**Modification  
instruction  
PICOGLOSS 560**

**Changing accumulators PICOGLOSS 560**

### 2. Step

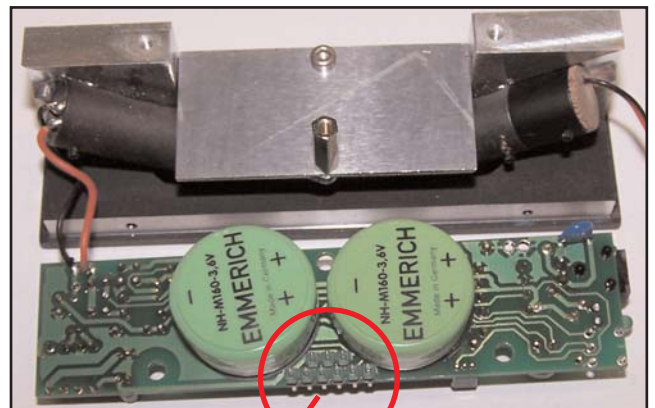
- dismantle PC boards
- unsolder the accumulators

### 4. Step

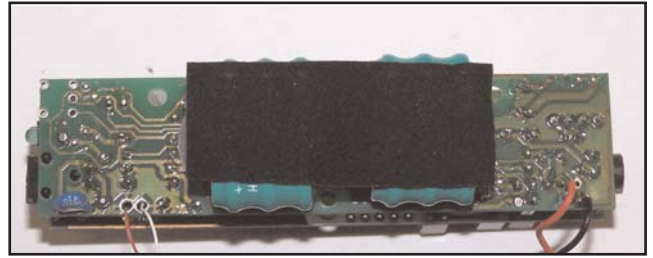
- remove covering plate

## 7. Step

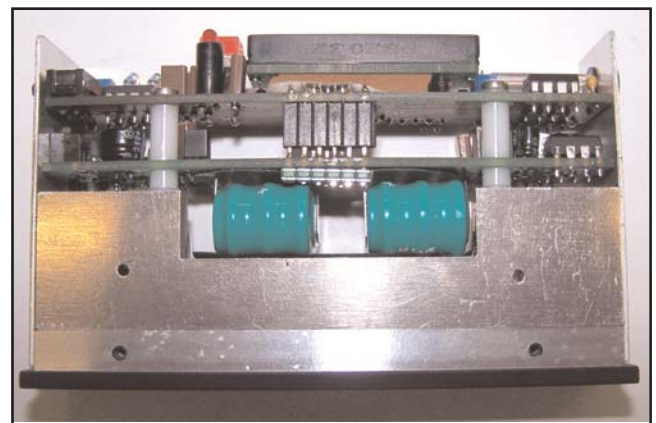
- replace the side panels and
- the cover

**Please note:** Slight pressure is needed when replacing side panels and cover, the accumulators are approx. 0.2 mm wider than the housing.
